UNITED STATES PATENT AND TRADEMARK OFFICE

| APPLICATION NO. | FILING DATE | FIRST NAMED INVENTOR | ATTORNEY DOCKET NO. | CONFIRMATION NO. |
|--|-------------|----------------------|---------------------|------------------|
| 10/707,619 | 12/24/2003 | Aaron Golle | 1748006US1 | 1478 |

| Office Action Summary | Application No. 10/707,619 | Applicant(s) GOLLE ET AL. | |

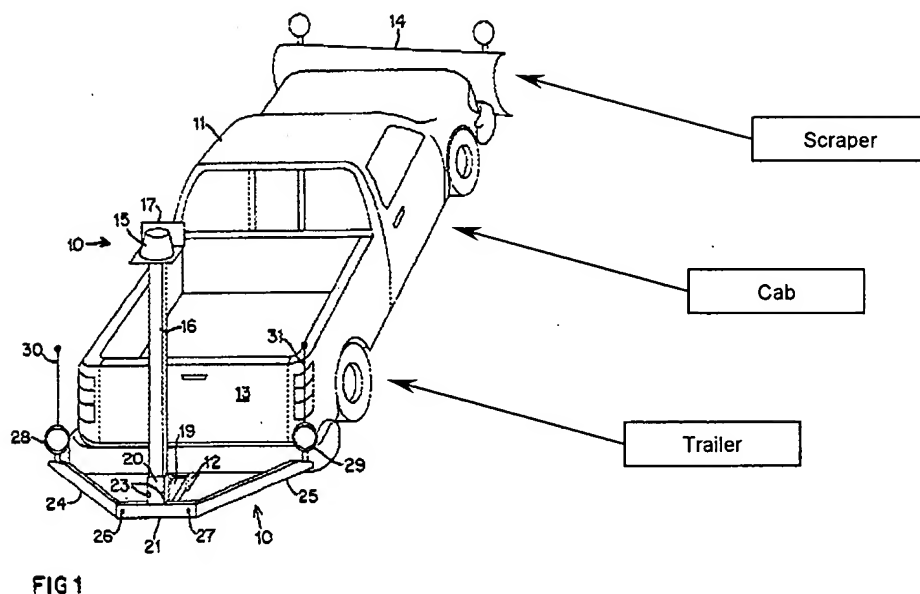
Pratt teaches a warning light for a vehicle, whereby the vehicle is a snowplow including a cab, trailer, and scraper [Figure 1 – note drawing below].

It would have been obvious to one ordinarily skilled in the art at the time of invention to incorporate the EL lighting device of Hoffman onto the cab of a snowplow of Pratt, in order to convey a message [e.g., safety or warning] or enhance visibility to other individuals/vehicles of the presence of the snowplow, and thus, enhance overall safety and prevent an accident. It should be noted that it is commonly known and obvious within the art to use signs on large vehicles to increase awareness of drivers and avoid accidents.
